Response to Action Item 19-19 Section 19.1

PRA Issue List Regarding APR-1400, DCD Tier 2, SECTION 19.1

Issue # PRA-19 (AI 19-19)

APR1400 DCD TIER 2

Attachment 1 – Chapter 19 DCD Markup for Question PRA-110

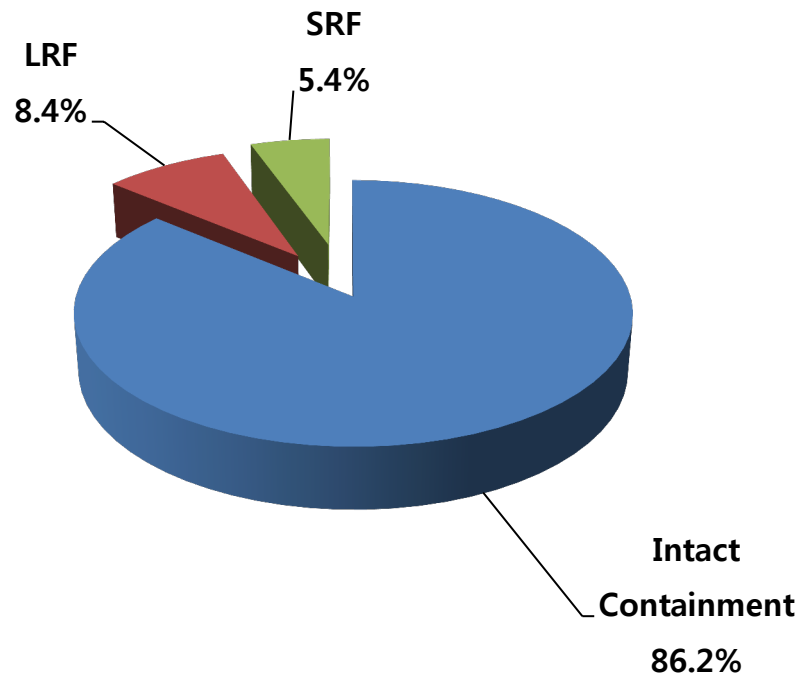
One label on Figure 19.1-50 is SRF. The abbreviation SRF did not seem to be defined in Chapter 19.

SRF is explained in Figure 19.1-50, and SRF is added to Acronym and Abbreviation List. (See Attachments 1 and 2.)
